## Product Change Notice (PCN)

**Subject:** Transfer Assembly Location from OSET, Taiwan to Greatek, Taiwan on Select Packages

**Revision Description:**

Revision 1 is to add supplement information where select package outline dimensions for products assembled at Greatek, Taiwan will not meet JEDEC standard.

**Appendix C – Package Outline Drawing Comparizon, SOJ28**

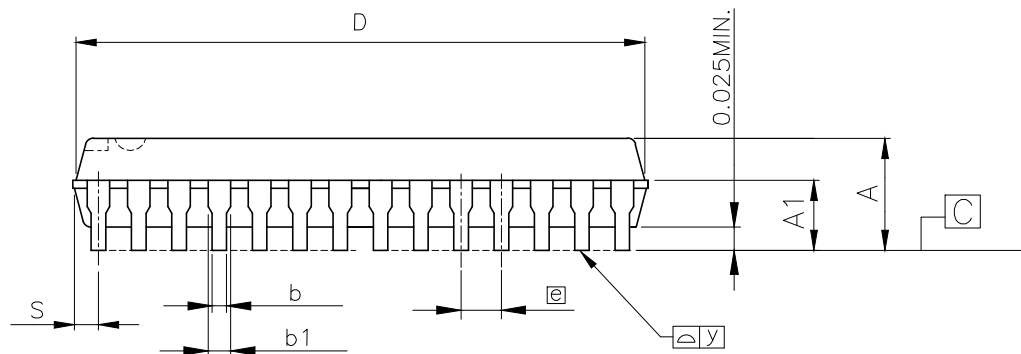
The material sets of the current and new assembly locations are as shown in the below table. The package outline drawing for SOJ28 assembled at Greatek, Taiwan will not meet JEDEC on select dimensions. Refer Appendix C.

Symbols	JEDEC			exIDT POD			Greatek POD			Remark
	MO-088			MO-088			NA			
	MIN	NOR.	MAX	MIN	NOR.	MAX	MIN	NOR.	MAX	
A	0.120	-	0.140	0.120	0.130	0.140	0.120	-	0.140	Greatek meet JEDEC/exIDT
A1	-	-	-	0.078	0.086	0.095	0.820	-	-	Greatek not meet exIDT
A2	0.025	-	-	0.025	-	-	0.025	-	-	Greatek meet JEDEC/exIDT
b	0.014	-	0.020	0.014	-	0.020	0.016	0.018	0.022	Greatek not meet JEDEC/exIDT
c	0.008	-	0.013	0.008	-	0.013	0.008	0.010	0.014	Greatek not meet JEDEC/exIDT
D	0.697	-	0.712	0.700	0.706	0.712	-	0.710	0.730	Greatek not meet JEDEC/exIDT
H	0.335	-	0.347	0.335	0.340	0.347	0.327	0.337	0.347	Greatek not meet JEDEC/exIDT
E	0.292	-	0.300	0.292	0.296	0.300	0.295	0.300	0.305	Greatek not meet JEDEC/exIDT
e1	0.262	-	0.272	0.262	0.267	0.272	0.245	0.265	0.285	Greatek not meet JEDEC/exIDT
e	-	0.050	-	-	0.050	-	0.044	0.050	0.056	Greatek meet JEDEC/exIDT

However, the footprint will remain unchanged as compared to the existing package assembled at OSET.
